STATE OF MAINE
DEPARTMENT OF TRANSPORTATION
16 STATE HOUSE STATION
AUGUSTA, MAINE 04333-0016

May 5, 2011
Subject: **Winthrop & Manchester**
Federal Project No: STP-1803 (700)X
State PIN: 018037.00
Amendment No. 4

Make the following changes to the Bid Document:

1 3/4" MILL & FILL SHOWING 4 TRAVEL LANES AND CENTER AUXILIARY LANE

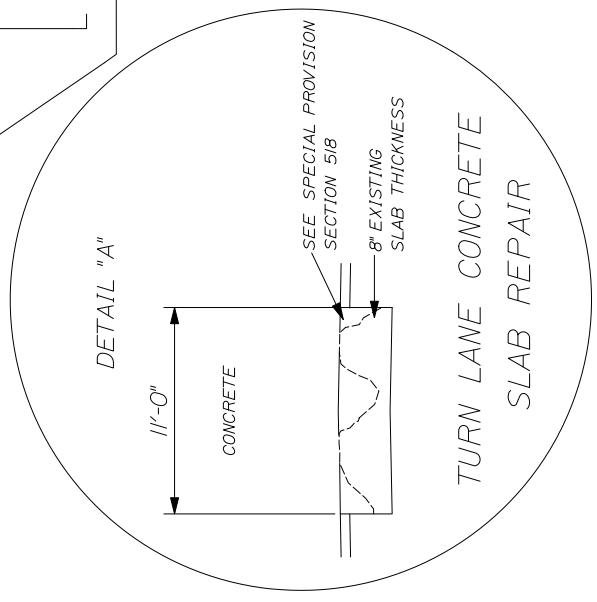
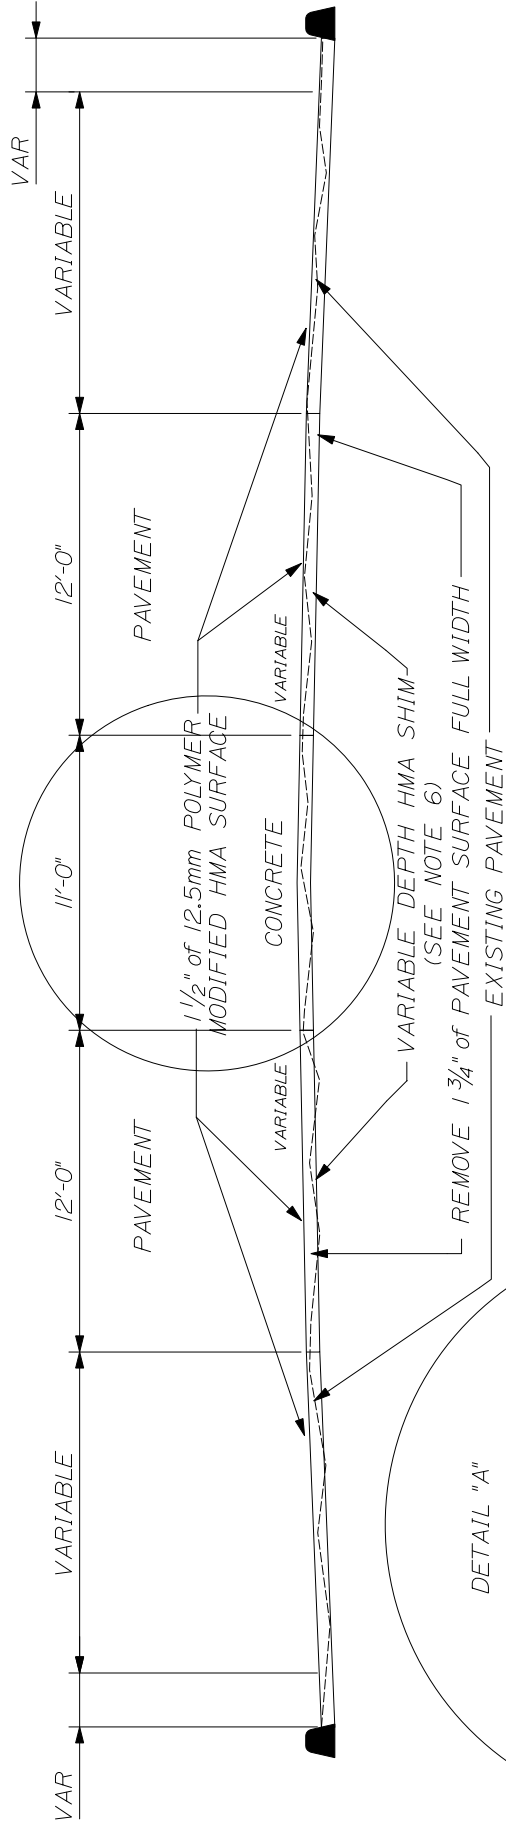
In the Bid Book (page 27) **REMOVE** the “TYPICAL SECTIONS, SHEET NUMBER 3 OF 4” 1 page and **REPLACE** with the attached new “TYPICAL SECTIONS, SHEET NUMBER 3 OF 4” 1 page.

Question: Please describe the center turn lane work in further details.

Response: Please see the changes in this Amendment. Due to additional information and further investigation, the concrete center turn lane will NOT be removed, it will remain in place and the deteriorated and cracked areas will be repaired according to special provision 518. The repair work should take into account the work hour limitations; given that the turn lane is used for business access and signal use. The intent is to have the repaired areas open to traffic as quickly as practical. The surface of the repair will match and be to a consistent grade and profile to the existing concrete wearing surface.

CONCRETE AREAS 907+08 - 939+68 +/-
940+88 - 949+84 +/- & 950+58 - 959+01 +/-
